Sandia National Laboratories

Date: December 21, 2006

Subject: Error in DRZ calculation in the Clay Seam G analysis

Figure 1: Comparison of the DRZ using the original ALGEBRA script (left) with that using the corrected script (right) at approximately 1 year for the gas generation factor $f=0.0$

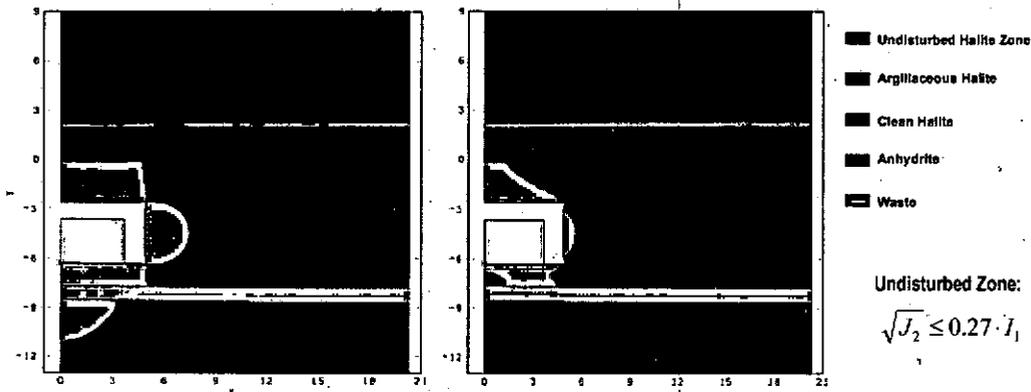
Figure 1 shows an example comparison of the DRZ using the original ALGEBRA script with that using the corrected script at approximately 1 year for the gas generation factor $f=0.0$. Figure 2 shows an example comparison of the SFZ using the original ALGEBRA script with that using the corrected script at approximately 1 year for the gas generation factor $f=0.0$. MSF in the figure is the minimum value of SF over all previous time steps. It is defined in this manner because, unlike salt, once the anhydrite fails, it does not heal.

The size of DRZ using the original scripts is much larger than that using the corrected scripts. The size of SFZ using the original scripts is also larger than that using the corrected scripts. This error affects the sizes of both the DRZ and SFZ, thus it should be corrected, because DRZ size changes with time will be accounted for in BRAGFLO calculations in PA for next CRA in 2009.

The recommended course of action is to correct the error, to repeat the post-process, and to rewrite Section 7.4, 7.5, 8, and Appendix B in the report for Clay Seam G [Park and Holland, 2004]. The sections and appendix revised by the post-process using the corrected ALGEBRA scripts are provided in Appendix A of this memo. The files related to the correction will be stored in the subdirectory of /data/bypark/clayg/correction/ in the CVS.

Figure 29: Change of the DRZ around a disposal room raised 2.43 m above the current level for the gas generation factor $f=0.0$

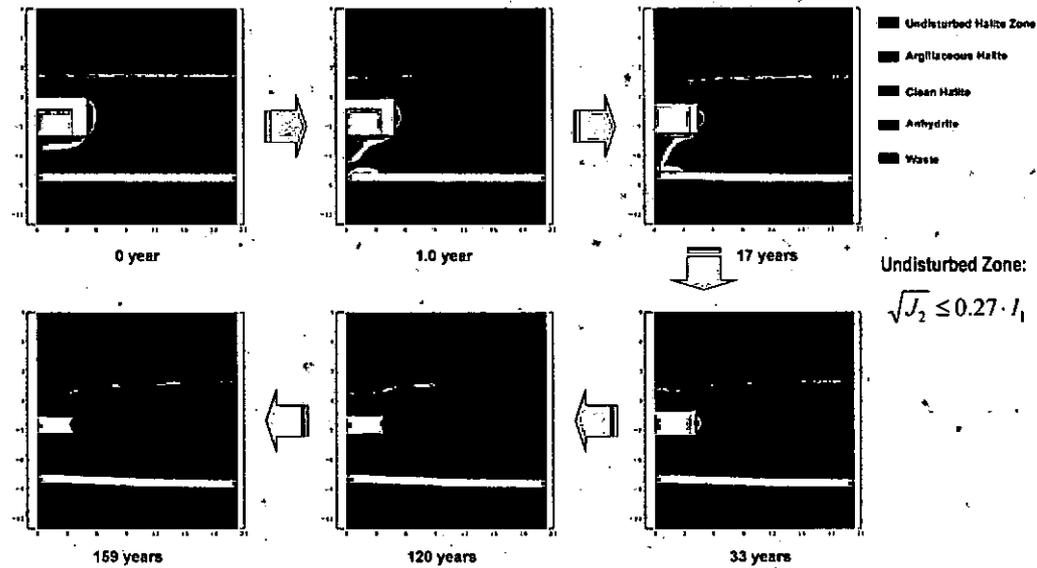
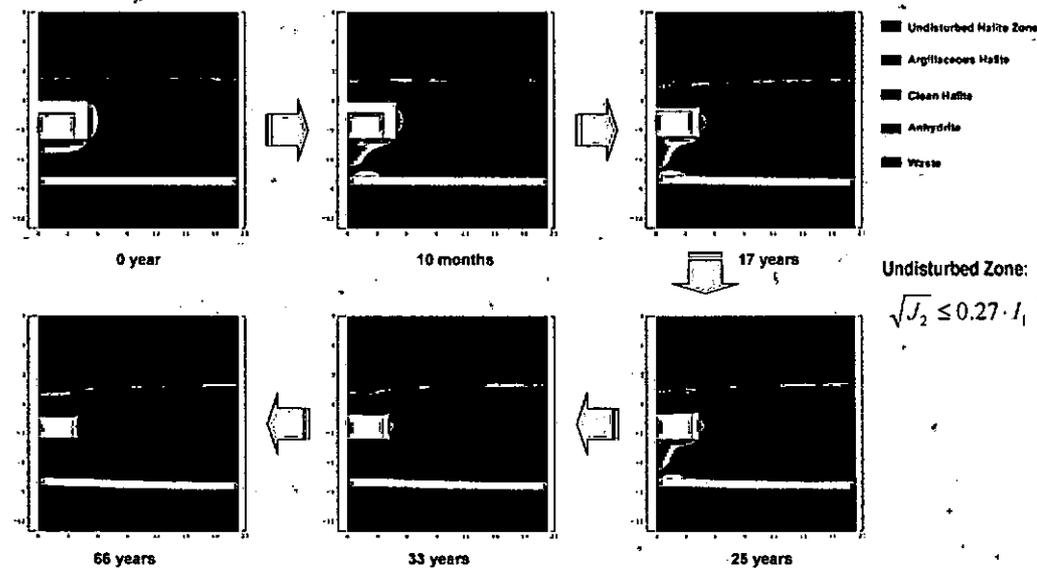
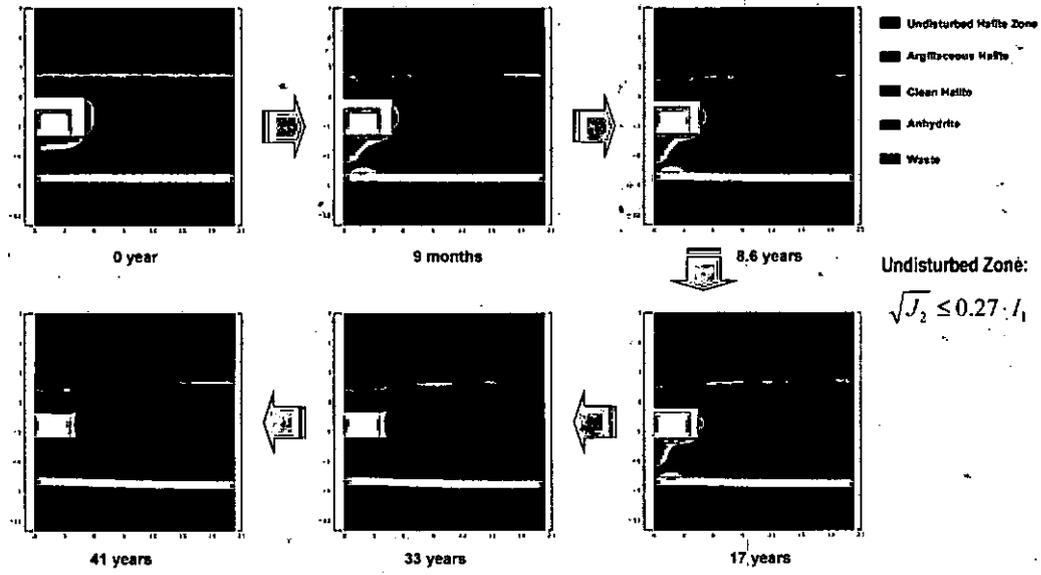
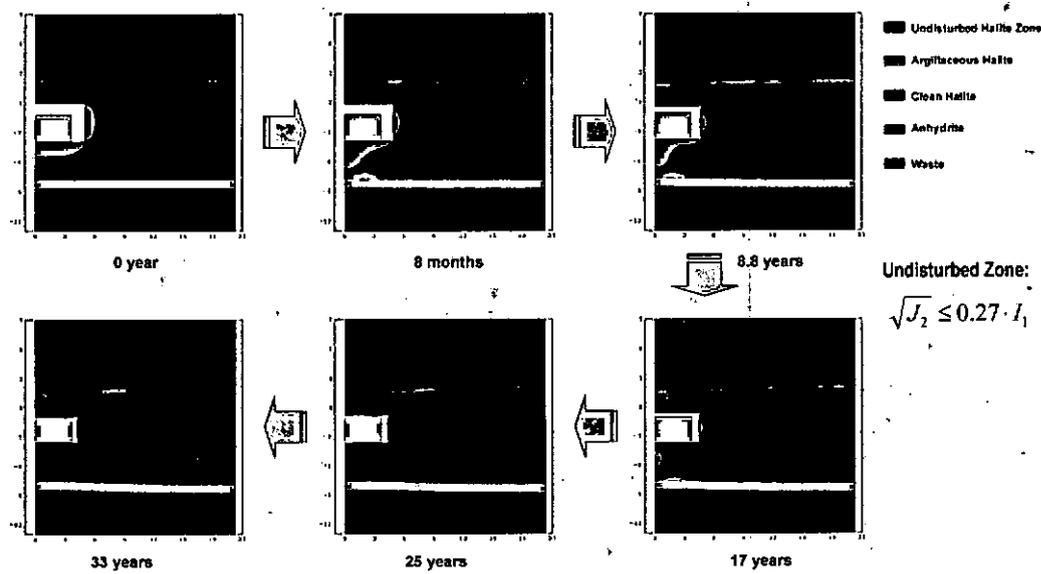
Figures 29 to 32 show the change with time of the DRZ around a disposal room raised 2.43 m above the current level for the gas generation factor $f=0.0, 0.4, 1.0$ and 2.0 . The undisturbed zone (dark blue zone) in the figures is defined by $D < 1$ in Equation 18 in Section 4. The most extensive DRZ occurs at early time, say in the first ten years after the opening is mined. As the back stress — caused by resistance to deformation of the waste stack — increases, the DRZ disappears according to the stress invariant criterion. The undisturbed zone no longer appears after the last time frame (6th frame) in the figures. This finding is consistent with other similar numerical simulations, such as Van Sambeek et al. (1993). They reported “A similar calculation for a brine-filled borehole or internally pressurized cavern shows that the thickness of the dilatancy zone depends on the internal pressure. The dilatancy zone around a cavern can be completely suppressed by an internal pressure equal to a small fraction of the lithostatic stress for the depth of the cavern.” Thus, calculations show that the damaged zone within the salt would heal.

The maximum extent of the DRZ calculated for the raised repository reaches approximately 3.8 m, the distance to the anhydrite layer (MB 139), below the room. The DRZ does not extend through the anhydrite layer that behaves as a buffer. The DRZ above the room disappears within a short period after the ceiling of room contacts the waste.

Figure 33: Change of the DRZ around a current disposal room for the gas generation factor $f=0.0$

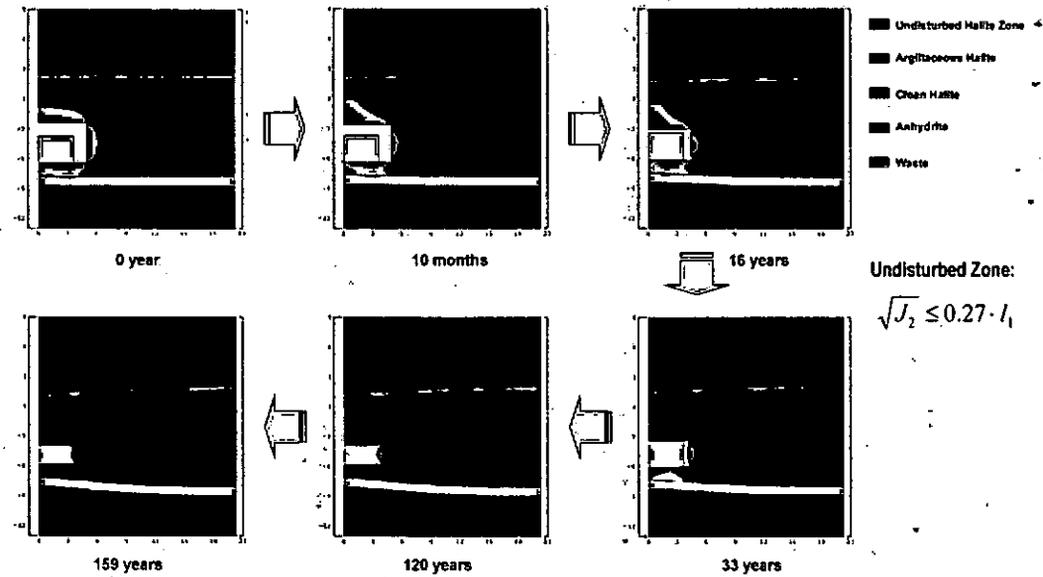
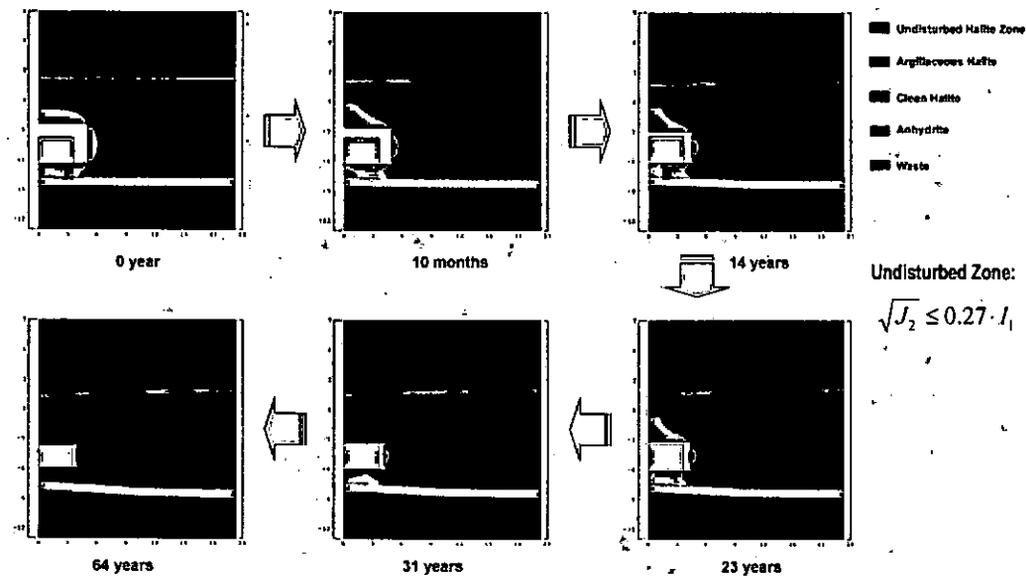
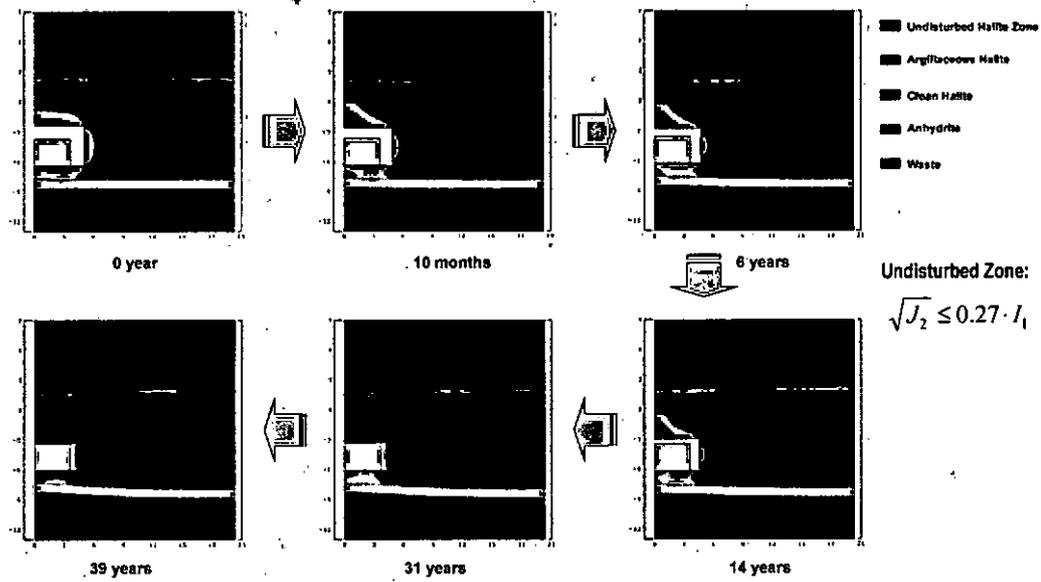
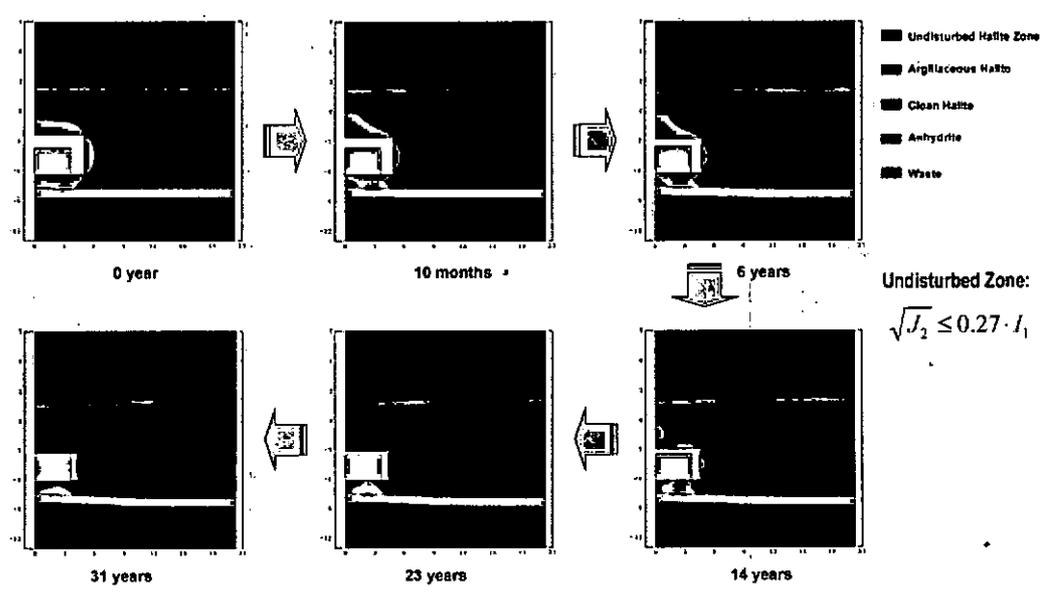
Modeling of the raised repository can be compared to Figures 33 to 36, which show the change of the DRZ around a disposal room at the current horizon with time for $f=0.0, 0.4, 1.0$ and 2.0 . The largest DRZ occurs early after the excavation for all f values, which is very similar to the case for the raised repository. The DRZ under the room does not extend through the anhydrite layer, in a manner similar to what happens in the case of the raised room. A maximum thickness of the DRZ is approximately 3.6 m over the roof of the room. The thickness of the DRZ in the floor of the present room is 1.4 m, the distance to the anhydrite layer. The DRZ does not extend through MB 139, the same as the case of the raised rooms.

Figure 37: Changes of the shear failure zone with time in the upper and the lower anhydrite layers of the disposal room being raised 2.43 m, $f=0.0$

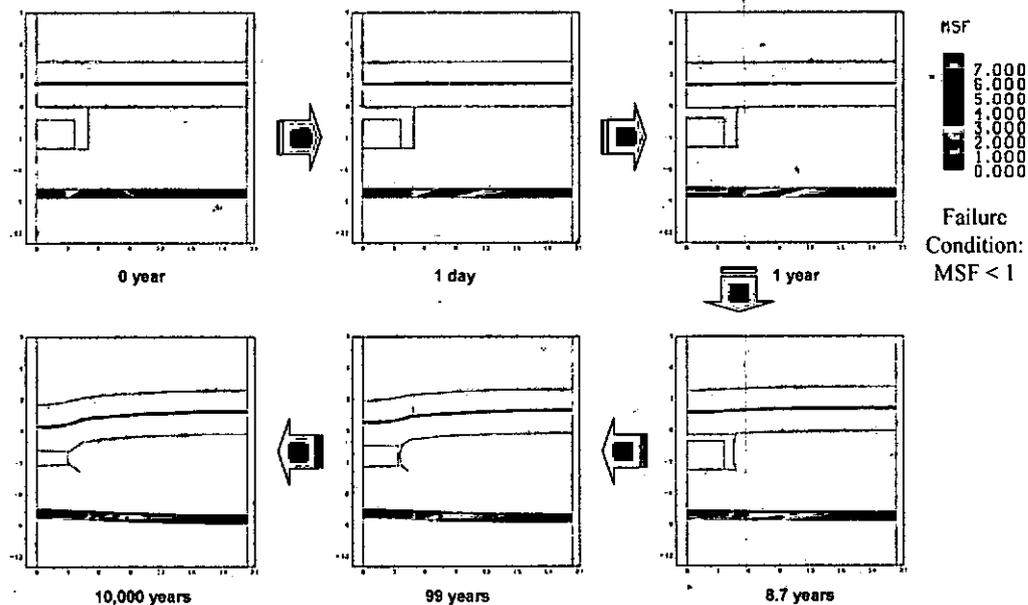
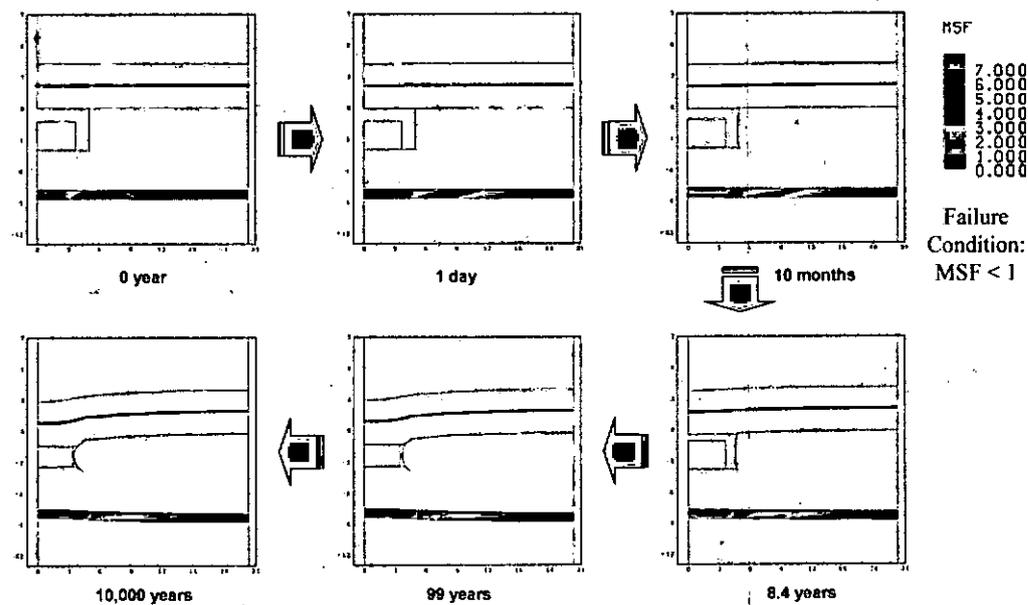
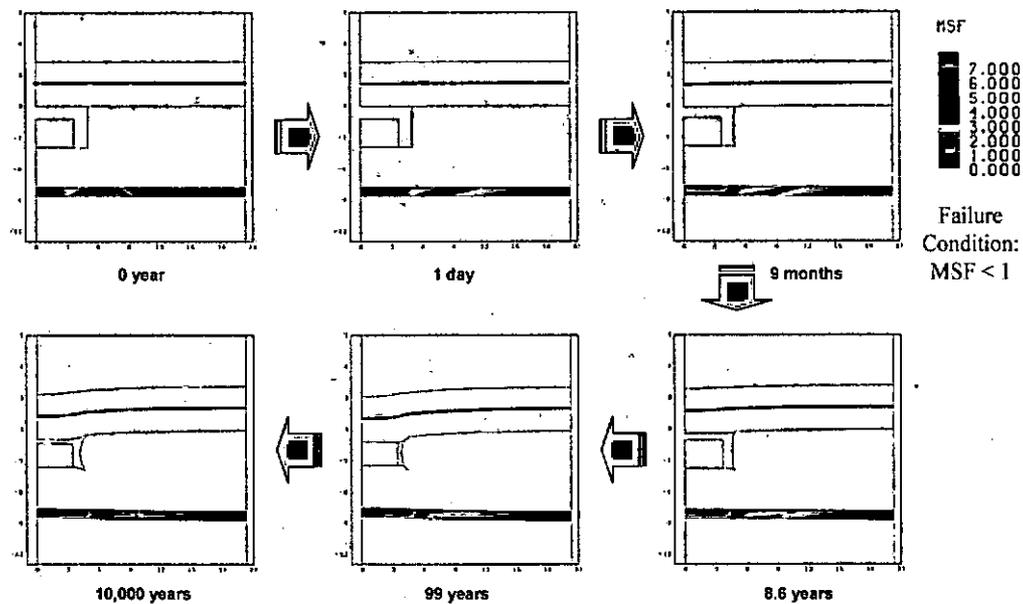
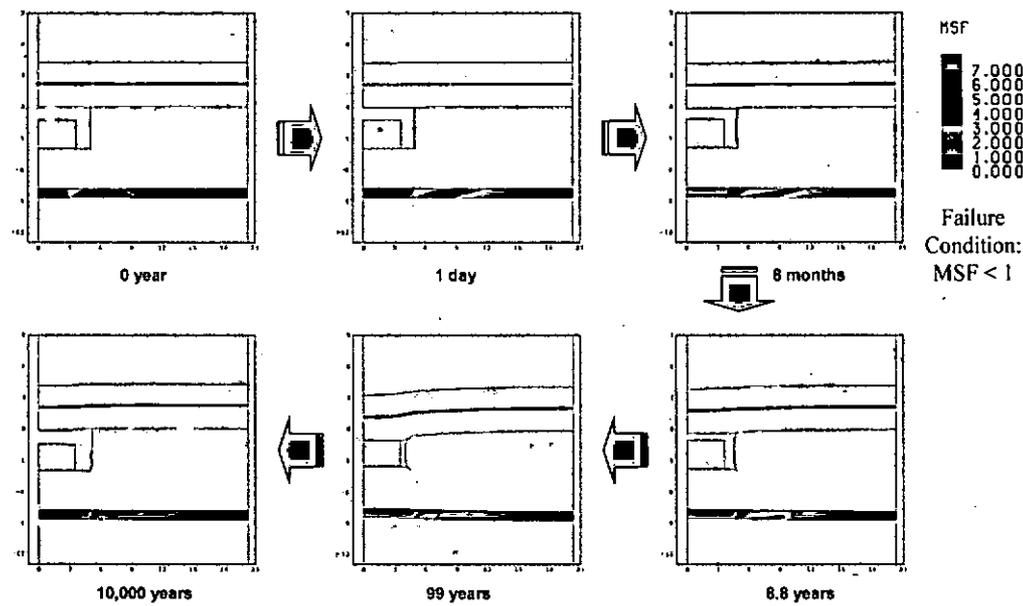
Figures 37 to 40 show the shear failure zones with time in the upper and the lower anhydrite layers of the disposal room being raised 2.43 m. The shear failure does not occur in either the upper or lower anhydrite layers at the moment of excavation, but appears above and below the middle of the pillar one day after the excavation. The shear stress in the anhydrite increases with time, therefore the extent of the failure zone also increases. The maximum extent of the shear failure zone occurs within the first 100 years. The internal gas pressure of the room does not affect the size of the failure zone in the anhydrite.

The distance between the bottom of the disposal room and the lower anhydrite layer is increased from 1.38 m to 3.81 m due to raising the room by 2.43 m. In other words, the current room is closer to Marker Bed 139. Because of this, the deformation of the anhydrite layer with the room closure is larger for the current room than the raised room. The shear failure zone is accordingly larger for the current room as shown in Figure 37 to 44.
